VISUAL DIFFERENCES IN BELT TENSIONER 55760

TECHNICAL INFO NO. 1034

RUVILLE-No.	OE-No.:
Ford	55760	95VW-10145-DA, 1039808
VW		028 903 315 R (new) 028 903 315 N (replaced)

Image 1: Design with two M8x35 bolts

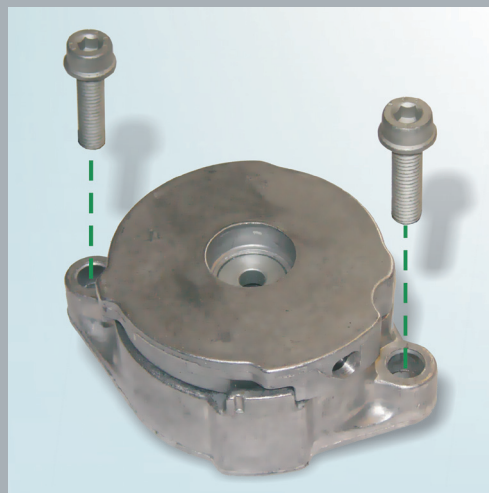
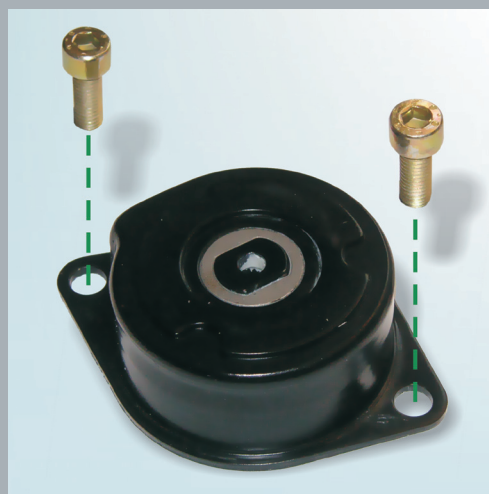
The bolts (M8x35) supplied by RUVILLE must be used due to the greater flange thickness of the belt tensioner 55760 (Image 1).

When replacing the belt tensioner 55760, the versions shown can be installed on the vehicle. RUVILLE currently offers the version shown in Image 1.

Both versions conform to technical requirements.
